These drawings have been prepared in support of

1) an application for listed building consent, supplementing the partially implemented consent ref 2014/0171/L 2) a Section 73 amendment to the partially consented planning application ref 2013/8263/P.

PROJECT NO / DRAWING NO

998/P025

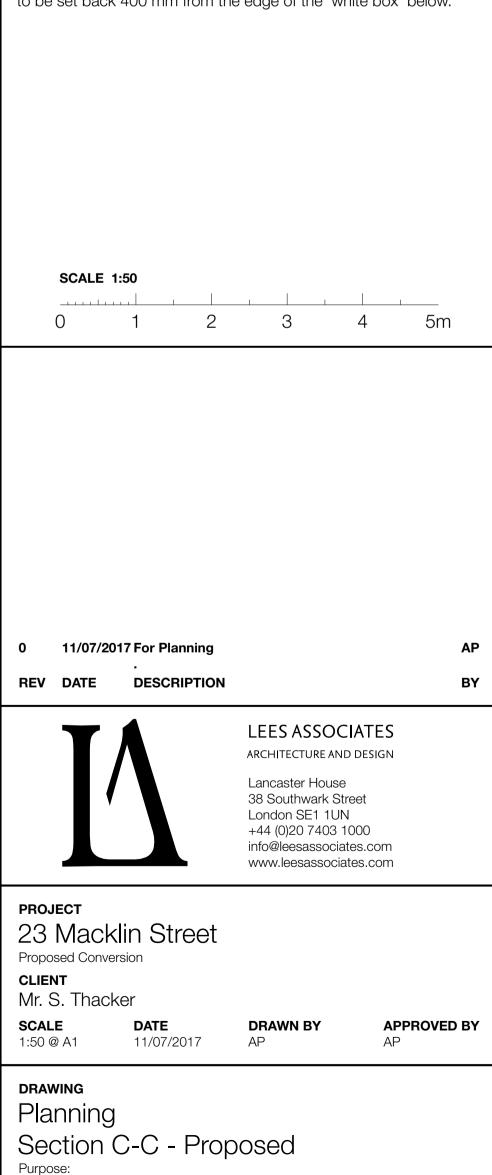
G.1 - Removal of modern main circulation stair and stair core, to be replaced with new stair with an open core.

1.1 - Removal of modern main circulation stair and stair core, to be replaced with new stair with an open core.

1.6 - Central bay window/door to remain as consented but to move in plan to match position of existing.

2.1 - Removal of modern main circulation stair and stair core, to be replaced with new stair with an open core.

2.2 - Windows to reman as consented but to move in plan to match position of existing. 3.1 - Replace the consented removal of the main circulation stair

with new, to align with below. Consented new stair up to Fourth Floor omitted.

4.1 - New stair as per Third Floor note 3.1

4.2 - Widening the existing terrace and replacement of existing solid balustrades with glass balustrades. Each side is to widen but to be set back 400 mm from the edge of the 'white box' below.
